Generator Tie-Line Tower 2/21 Relocation

Petition to Modify
the
Oakley Generating Station
Oakley, California
(09-AFC-4C)

May 2016

Figure 1
Transmission Tower Locations
 Oakley Generating Station
 Oakley, California

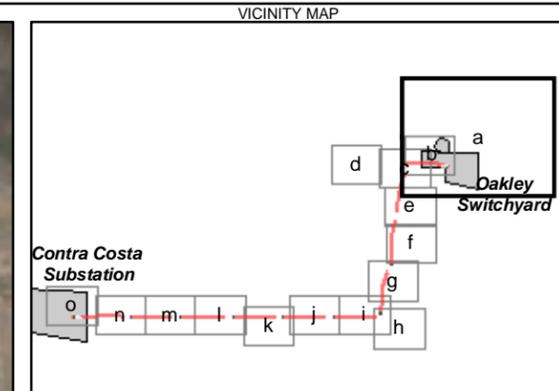
In addition, 17 existing steel lattice towers will be removed and replaced with more aesthetic tubular steel towers as part of this project (Figure 1). With these modifications, the number of tower replacements would be reduced by 1 to 16. This does not make a significant difference in terms of visual resources.

Figure 2a
Comparison of Existing and Proposed Facilities
 Oakley Generating Station
 Oakley, California

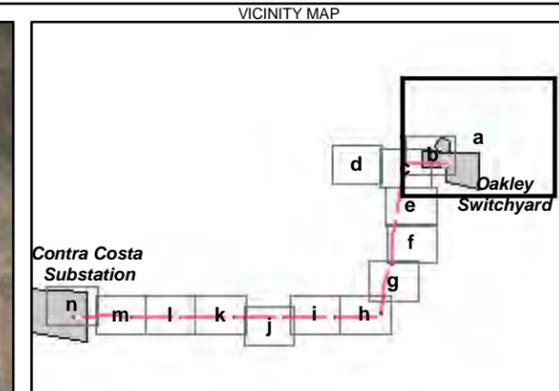
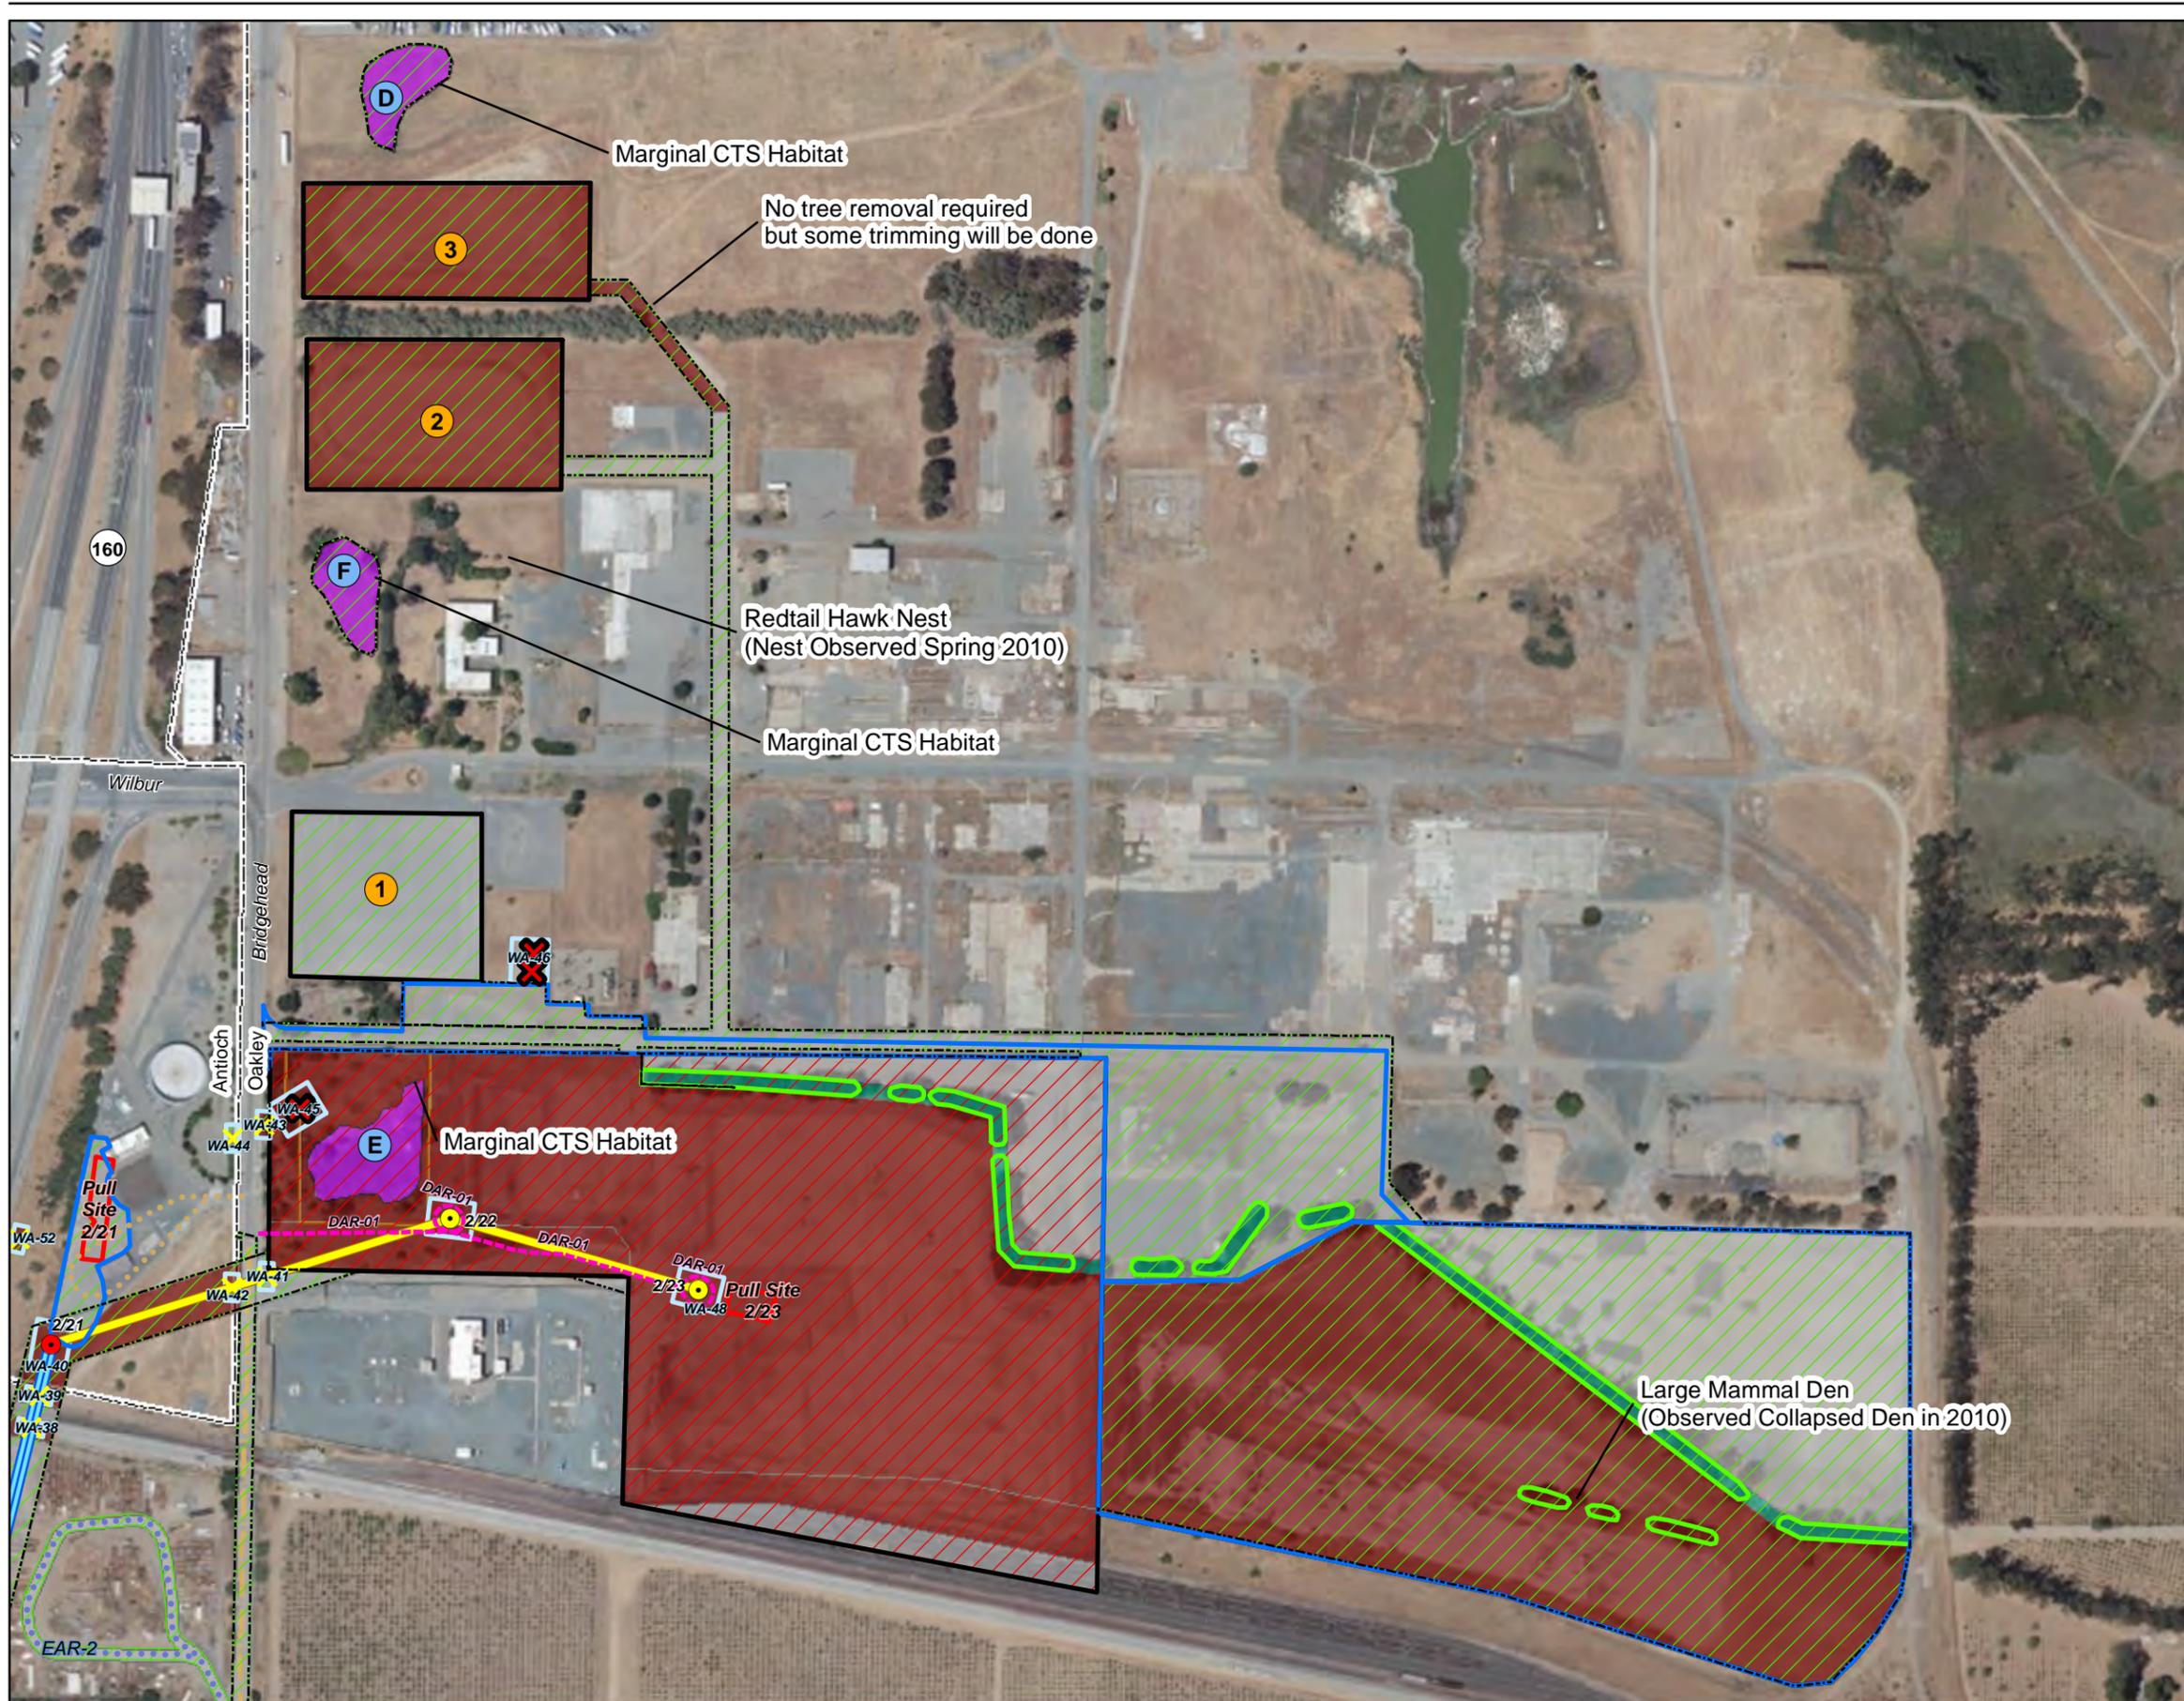
The requested modification is a minor change in the location of generator tie-line conductor support tower 2/21 and a corresponding minor modification to the generator tie-line alignment between tower 2/21 and tower 2/22. There are corresponding minor changes in the locations and shapes of the pull and work area sites that are located outside of the generator tie-line right-of-way and result in both deletions and additions of work areas. These changes result from minor refinements and additions to the generator tie-line design and construction plan being finalized by PG&E. They are needed because the previously proposed location of the tower is no longer available for use.

Under the existing design, the generator tie-line leaves the OGS project site at Tower 2/22 and extends due west across Bridgehead Road to Tower 2/21, where the existing steel lattice tower would be replaced by a steel tubular tower and the line would turn south. Since the OGS was licensed, however, cell phone transponder equipment has been installed on the steel lattice tower, making it unavailable as an OGS generator tie-line tower site. Tower 2/21 will therefore be moved to the south approximately 225 feet within the same right-of-way, to a location just north of the railroad right-of-way. The associated pull sites and work areas outside of the right-of-way will be modified to match the new tower location. Table 1 shows project acreages under the current design for elements affected by the modification, the proposed new acreages under the modification for these elements, and the net change in project acreages of the modifications, taking into consideration both the increases and decreases in project element acreages that result from the proposed modification.
